SUNDRY NOTICES AND REPORTS ON WELLS (DO NOT USE THIS FORM FOR PROPOSALS TO DRILL OR TO DEEPEN OR PLUG BACK TO A DIFFERENT RESERVOIR. USE "APPLICATION FOR PERMIT" (FORM C-101) FOR SUCH PROPOSALS.)		WELL API NO. 30-025-42461

2. Name of Operator Solaris Water Midstream, LLC		6. State Oil & Gas Lease No.
3. Address of Operator 9950 Woodloch Forest Drive, Ste. 3800, The Woodlands, TX 77380		7. Lease Name or Unit Agreement Name Wild Cobra 1 State SWD

Wild Cobra 1 State SWD 2

Operator: SOLARIS WATER MIDSTREAM, LLC 9950 WOODLOCH FOREST DR THE WOODLANDS, TX 77380	OGRID: 371643
	Action Number: 526421
	Action Type: [C-103] NOI Workover (C-103G)

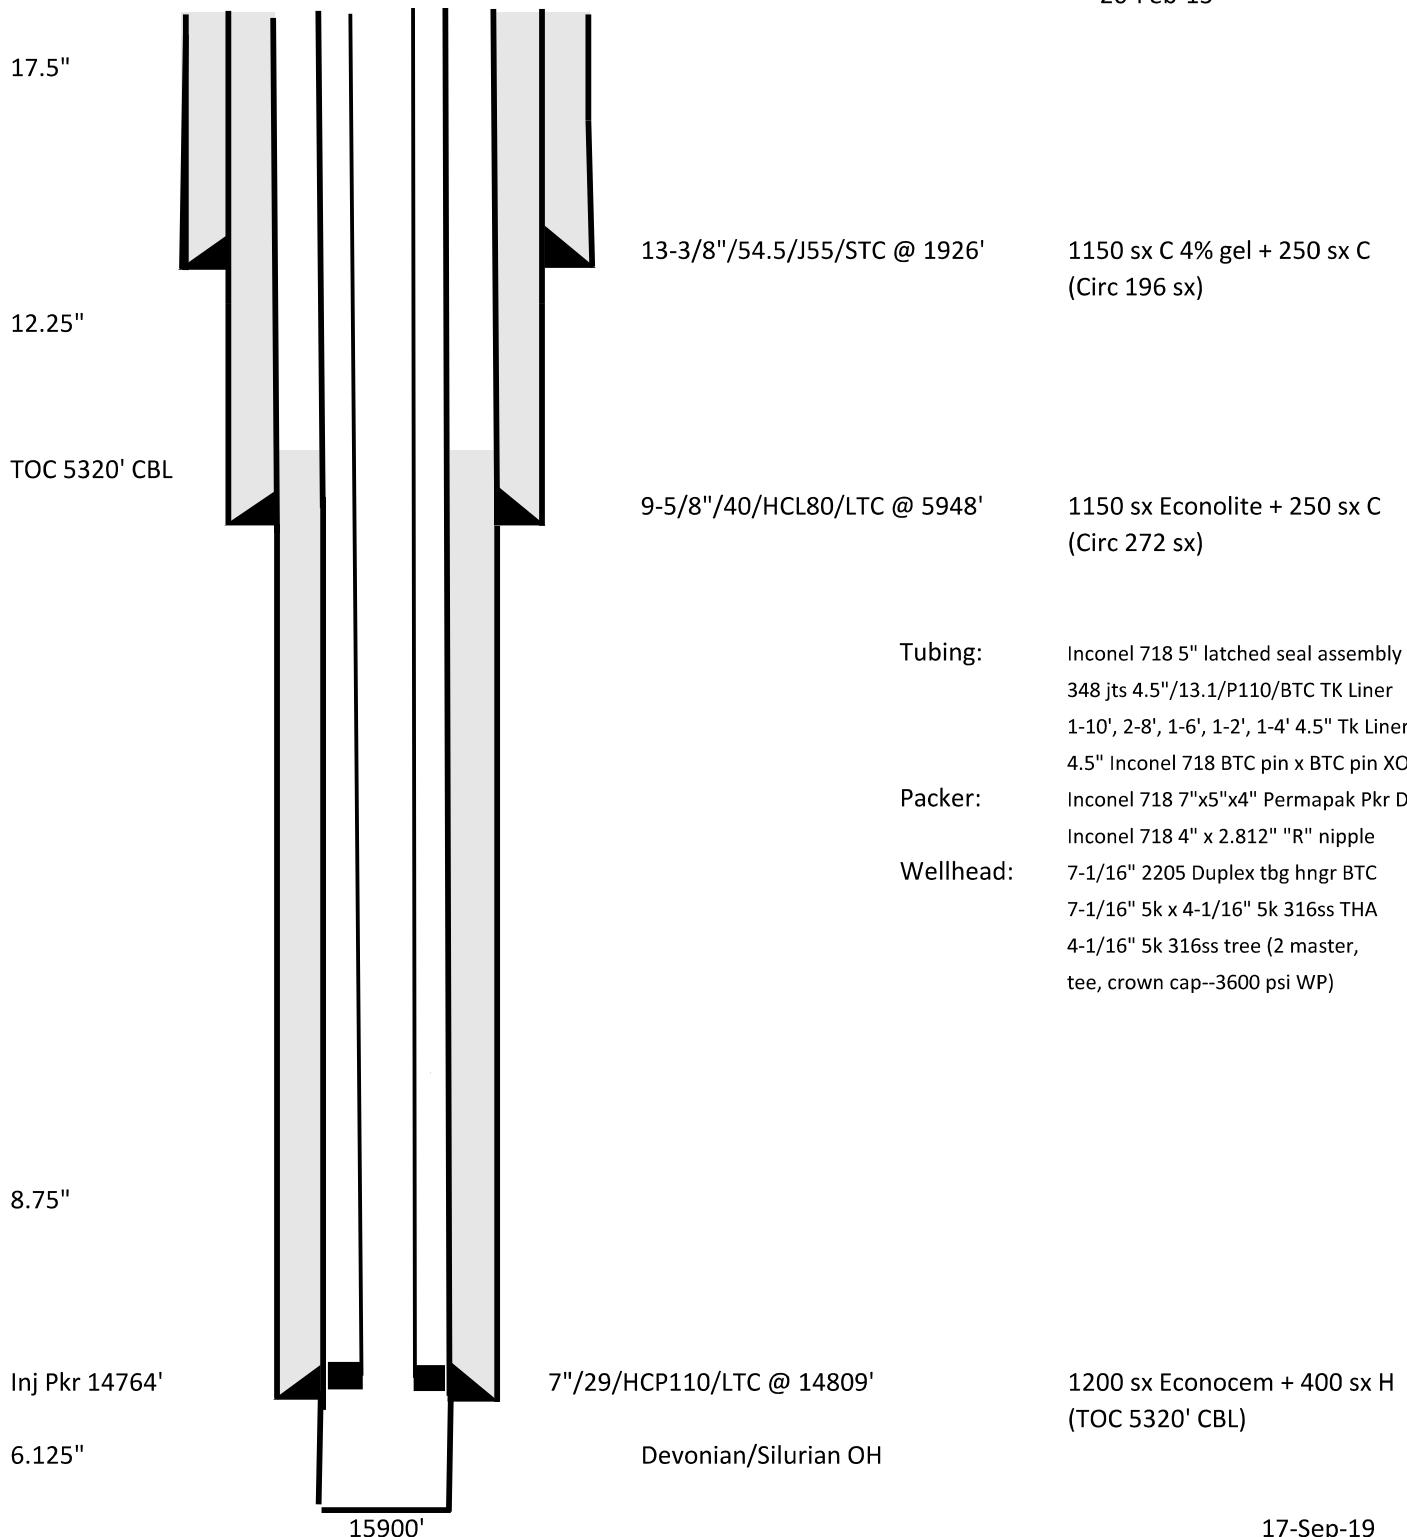
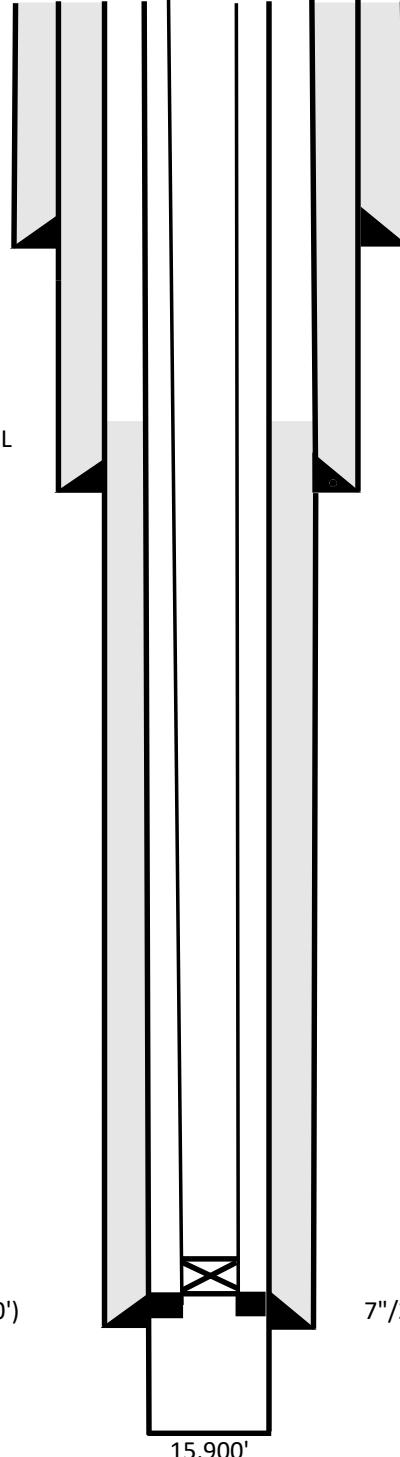
Solaris Water Midstream, LLC would like to give notice of intent for a remedial workover on the above captioned well to repair suspected parted tubing below the hanger. The plan is to rig up a pulling unit with hydraulic BOP and pick up tubing string and pull out of the hole with parted tubing, leaving the existing permanent packer in place.

Tree components and tubing threads will be inspected on the way out and damaged equipment will be replaced with new ones. Injection string will be the same 4-1/2", 13.1#, P-110, BTC, TK Liner from surface to 14,760' with the same permanent packer COE @ 14,764'. A new MIT and BHT will be called out and performed after the workover to ensure wellbore integrity.

Created By	Condition	Condition Date
pgoetze	Supersedes NOI approved by OCD April 14, 2025. As stipulated previously, new tubing shall be the same diameter as currently in the well. Operator shall notify Inspection Supervisor 24 hours prior to conducting MIT for return to service to allow test to be witnessed.	11/25/2025
